ADA Compliance Program

Clark County Facilities Transition Plan

Franklin Building

Date of Survey: July 10, 2006

Fig. 307.2
Limits of Protruding Objects

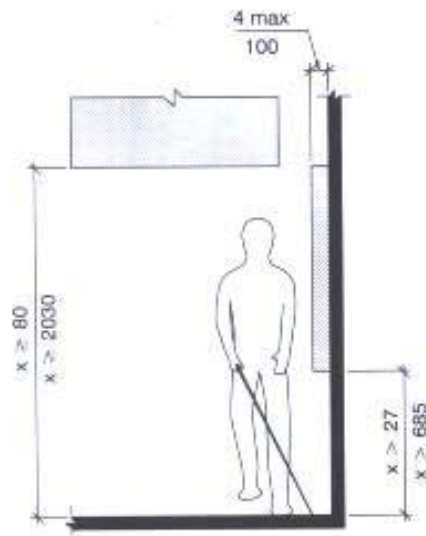
Item: Drinking Fountain – 1st Floor Lobby – Protrusion Limits

ANSI 307.2 Protrusion Limits. Objects with leading edges more than 27 inches and not more than 80 inches above the floor shall protrude 4 inches maximum horizontally into the circulation path. The drinking fountain shown protrudes significantly into the hallway and the height exceeds the 27 inch minimum.

The fountain should be recessed into an alcove or protected by cane detectable barriers.
